# Comhairle Chontae Atha Cliath Theas

**PR/0918/22**

**Reg. Reference:** SD21A/0167      **Application Date:** 25-Jun-2021  
**Submission Type:** Significant      **Registration Date:** 25-May-2022  
Additional  
Information

**Proposed Development:** Construction of a gas fired power plant with an electrical output of up to 125MW with associated balance of plant, equipment and buildings including; an Engine Hall building with a height of 18.9m, comprising 6 gas engines and ancillary infrastructure; an Electrical Annex Building with a height of 18.7m; a Workshop building with a height of 5.1m; a Tank Farm building with a height of 5.68m; a Security hut with a height of 3.27m; an Exhaust Stack with a height of 31.8m; a Gas AGI including a kiosk with height of 3.3m; Radiator Coolers with a height of 8.46m; 2 electrical transformers with a height of 4.98m; Tanks including 2 x Diesel Oil Storage Tanks (volume of 2500m<sup>3</sup> combined); SCR Urea Tank (26m<sup>3</sup>); Lube Oil Storage Tank (26m<sup>3</sup>); Lube Oil Maintenance Tank (26m<sup>3</sup>); Pilot Oil Tank (26m<sup>3</sup>); Fire Water Storage Tank (1000m<sup>3</sup>); Effluent Collecting Tank (26m<sup>3</sup>); Under

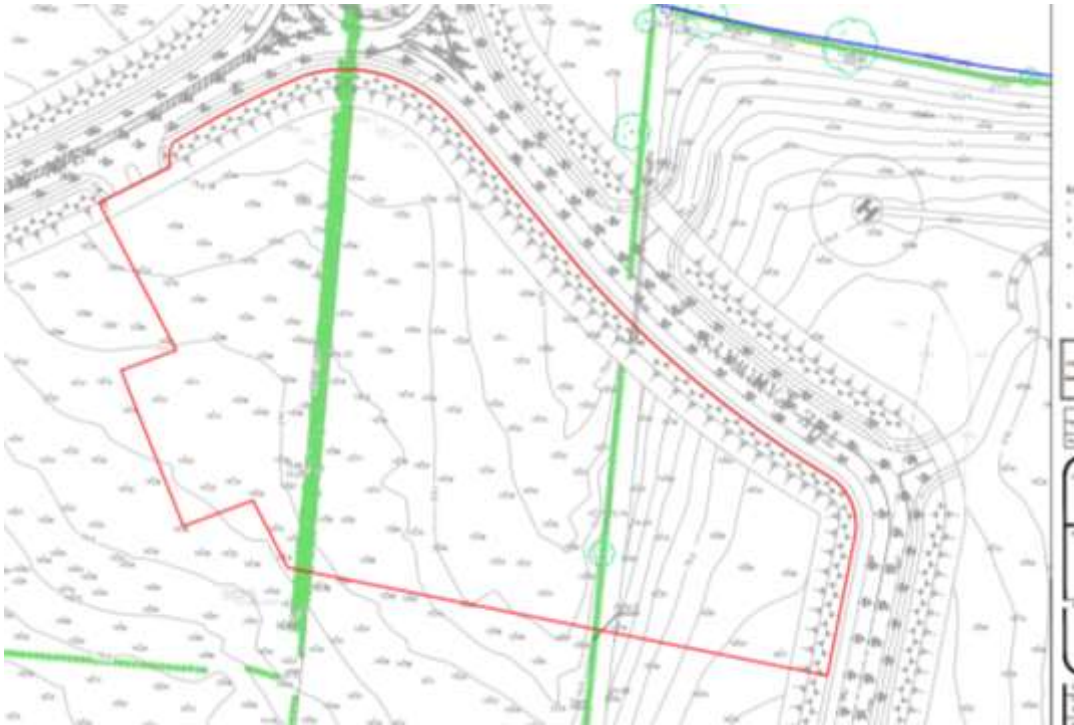
In relation to (a) (iv) the applicant has reduced the scale of the stacks by 3.8m. This gives an overall height of 28m, a significant reduction from the previous proposal. The visuals submitted indicate that it is still a bulky structure, with the stacks enclosed within a building. The stacks would be visible from long distances and have the potential to become a landmark with views from significant distances from the site. The Planning Authority would welcome a reduction in the bulk of the structure and reconsideration of the design, which is monotone at present.

**Clarification of additional information** is therefore requested in this regard.
